Memo Template for GDC Hearing – Eastland Port – Twin Berth project.

PDP was requested in September 2023 by Planning Works to undertake a desktop peer review of the Eastland Port Limited (EPL) Twin Berth reports in terms of the stormwater treatment process and discharge quality, on behalf of GDC.

Figure 2: Proposed Treatment Train with bypass system (Cheal Stormwater Engineering report)

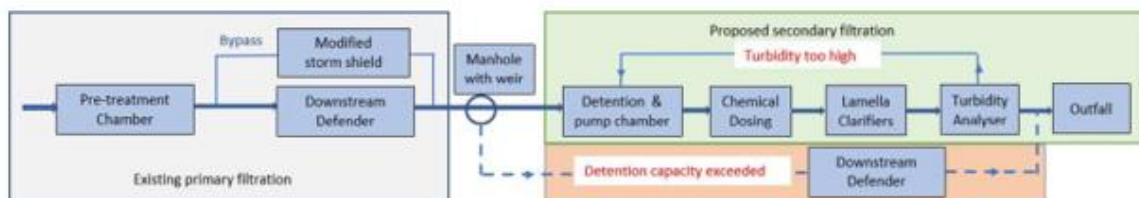
Ponding occurs in both the south and north sub-catchments. To mitigate ponding, additional treatment devices (hydrodynamic vortex separators) will be installed in the bypass flow paths in the north and south sub-catchments as outlined in Figure 2.

- The bypassed discharge is the main concern. With the type of contaminants/material discharged from the site, a hydrodynamic Vortex Separator, may not treat much of the stormwater that bypasses the main treatment system. Therefore, it is important to review and determine the rain events and flow rates that should be pragmatically treated.
